K085491XS / KP85491XS-1 / KP85491XS-2

VAG 1.8/2.0 Petrol

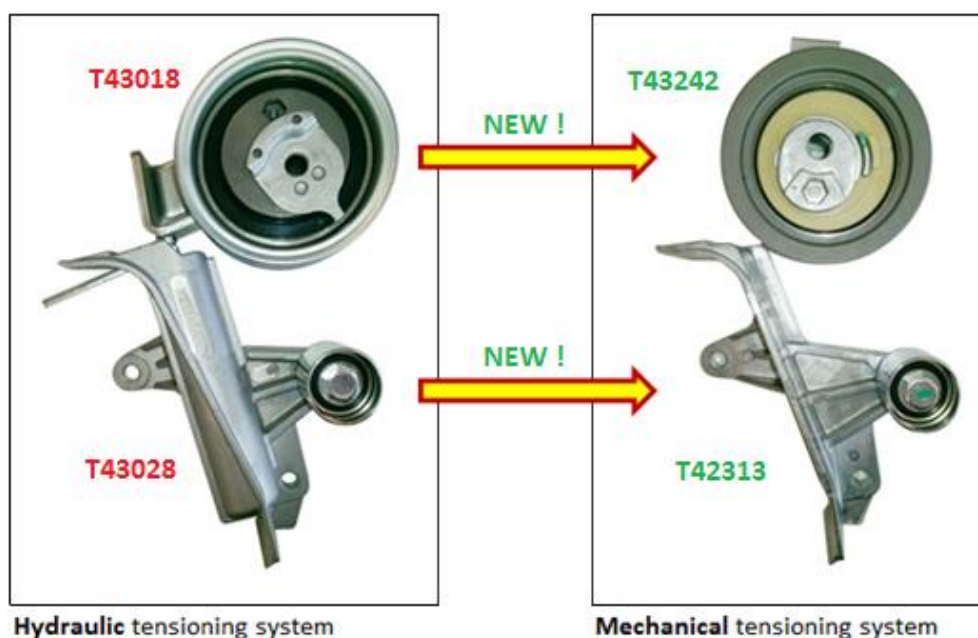
There has been a modification at OES level, regarding the tensioning system on some VAG 1.8/2.0 petrol engines, using the equivalent of our 5491XS belt in the Aftermarket.

The **hydraulic** tensioning system (tensioner T43018 + vibration damper T43028) has been replaced by a **mechanical** tensioning system (new tensioner T43242 + new idler bracket T42313).

This new idler bracket T42313 is of almost exactly the same design as the previous vibration damper T43028, but without the hydraulic element - it's only a metal bracket with a small touch idler.

Separate components of the *hydraulic* tensioning system are **not interchangeable** with the components of the *mechanical* tensioning system. Similarly:

- The new tensioner (T43242) **cannot** be used in combination with old hydraulic element (T43028)
- The new bracket (T42313) **cannot** be used in combination with the old tensioner (T43018)
